# Access Compliance Report

## Public Rights-of-Way

### (Curb Ramps)

Intersection ID: 18820	Main Street: SEVENTY SEVEN CENTER DR	Cross Street: TYVOLA RD	Location: E
ADA ID: E0100D7C0148	Ramp Type: PerpDiag	Initial Pass/Fail: Fail	Overall Compliance: No
Severity Score: 12.5			
Codes/Mitigation Info/Possible Solution		Field Measurements/Component Compliance

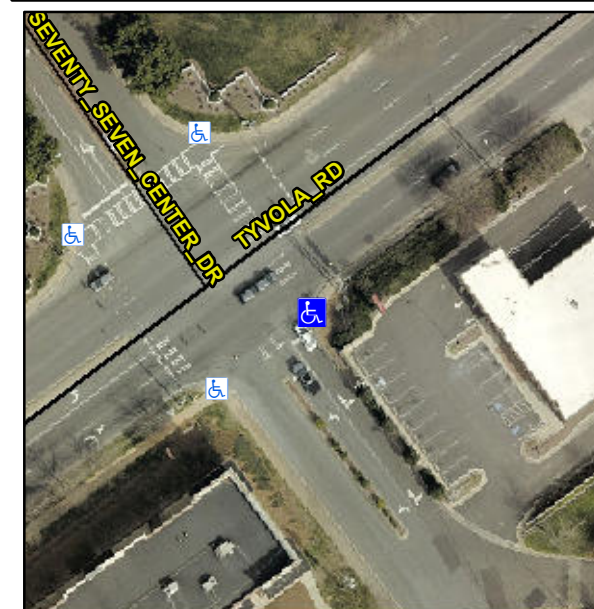
**Remove & Replace Curb Ramp With Two New Directional Ramps or Equivalent.**

**Not Found, R304.2.2**
